DESIGN ADVISORY BOARD Tuesday February 23, 2016 at 3:00 PM Conference Room 12, City Hall, Burlington, VT Agenda

TO: Design Advisory Board
FROM: Scott Gustin *AG*
DATE: February 23, 2016
RE: 16-0814CA/CU, 20 Fletcher Place

Request: Construction of 3-unit residential building with associated drive and parking.

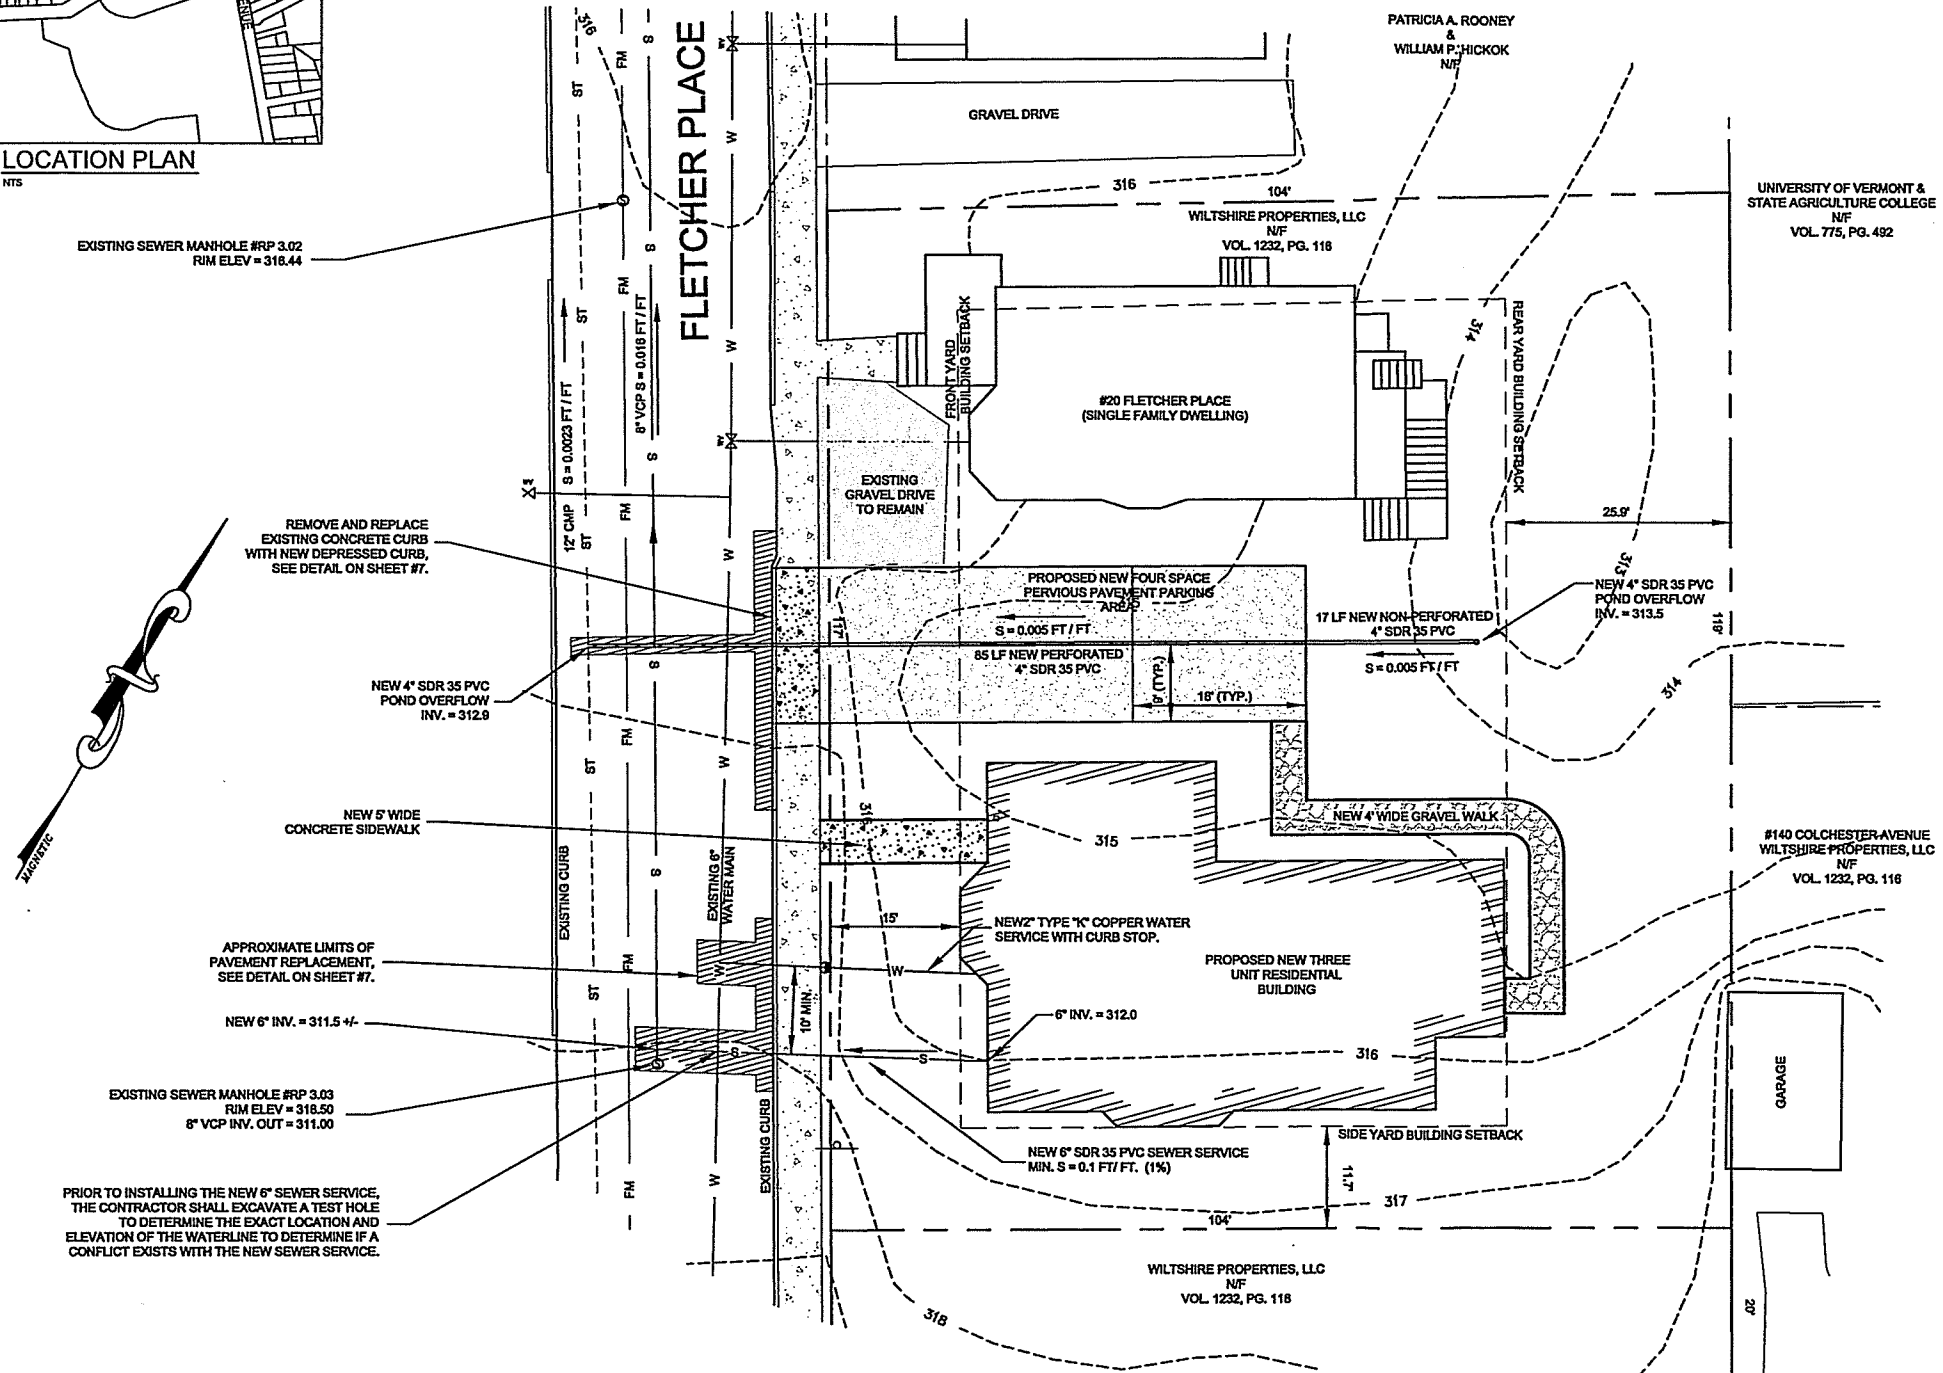
A new front walkway will provide pedestrian access from the public sidewalk to the front entry. Another walkway will provide pedestrian access from the driveway to the rear entry. Note that this second walkway will be gravel. While acceptable, there must be a hard border between the gravel's edge and the abutting lawn.

Although minimum parking standards are specified under Article 8 of the CDO, it bears noting here that the proposed parking is inadequate. A single 2-car wide driveway is proposed. The plans note 4 parking spaces – 2 pairs in tandem. Tandem parking arrangements are only acceptable for single family homes and duplexes. As the proposed construction is a triplex, only 2 of the parking spaces can be counted towards the minimum parking requirement. Each space needs to be accessible without moving another vehicle.

New utility lines must be buried. Utility meter locations are not evident and must be noted and screened. No mechanical equipment is noted either. If any mechanical equipment, such as an AC compressor, is proposed, it must be depicted on the site plan and screened.

LANDSCAPING PLAN

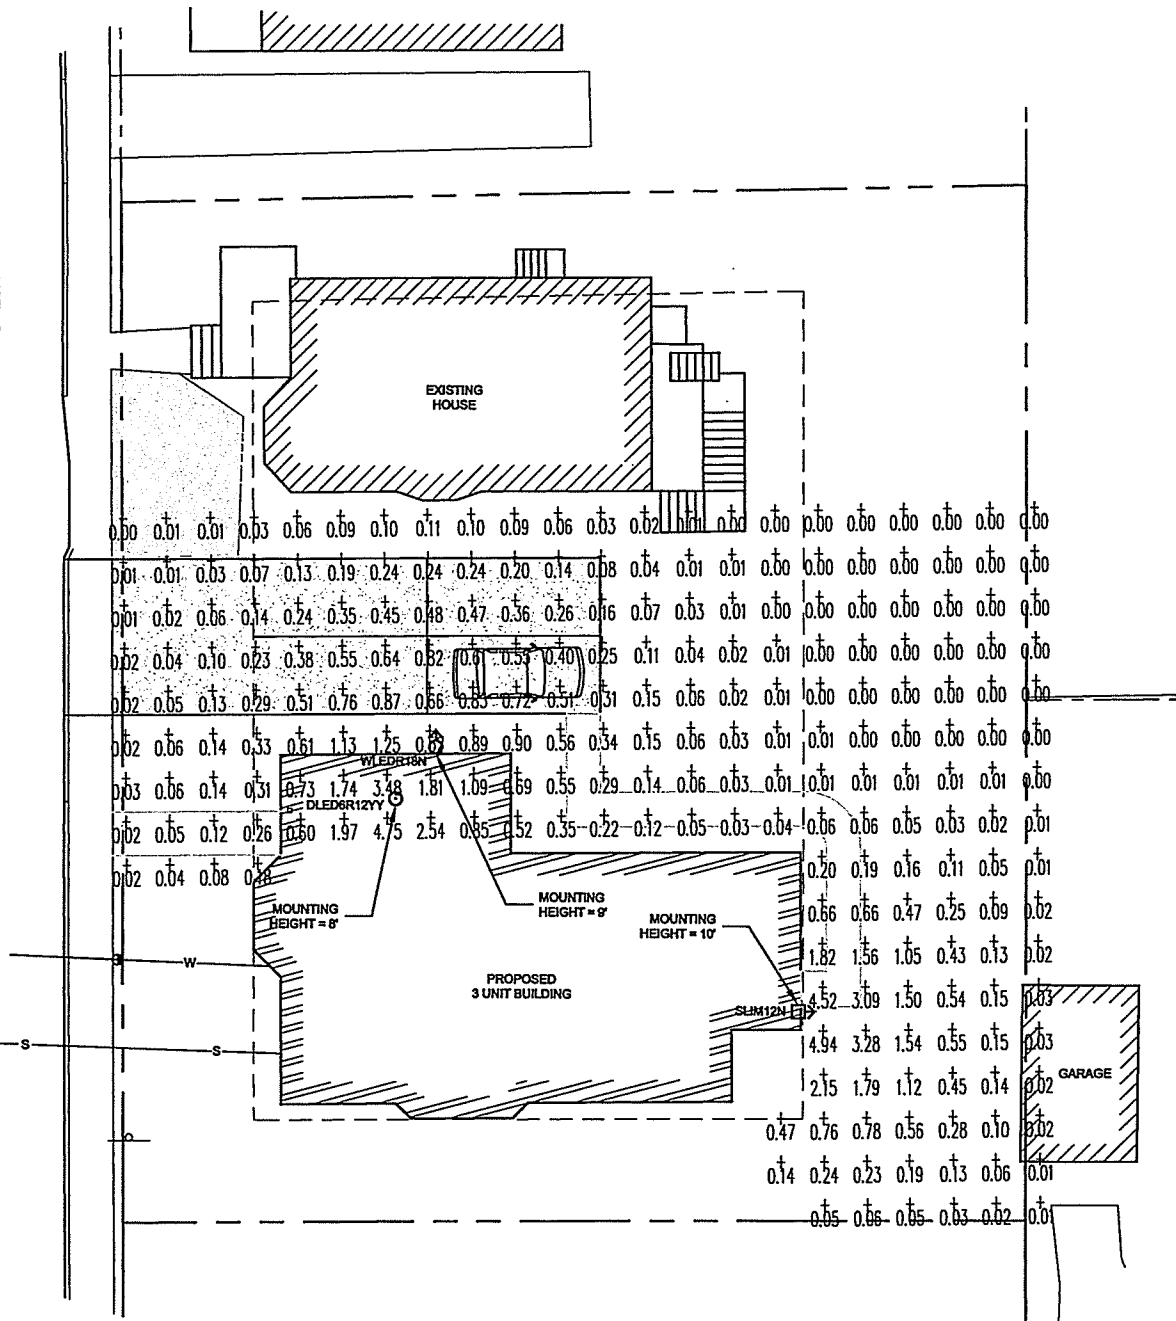
A landscaping plan has been provided. Gardens are proposed along much of the building's perimeter with several new trees planted within the lawn. As proposed, the landscaping plan is fairly typical for new home construction.

Basement sliders no grill

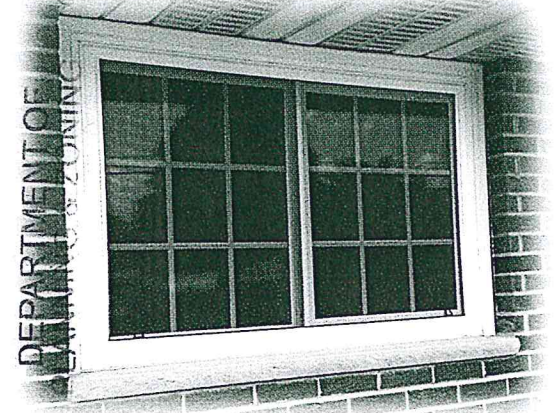
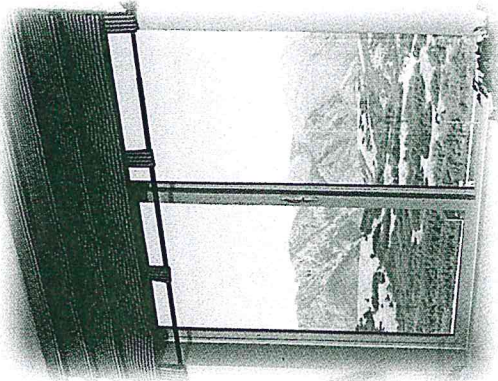
applicant is encouraged to consider cedar basement windows. The applicant is encouraged to work out a longer time frame to replace the rest of the vinyl windows.
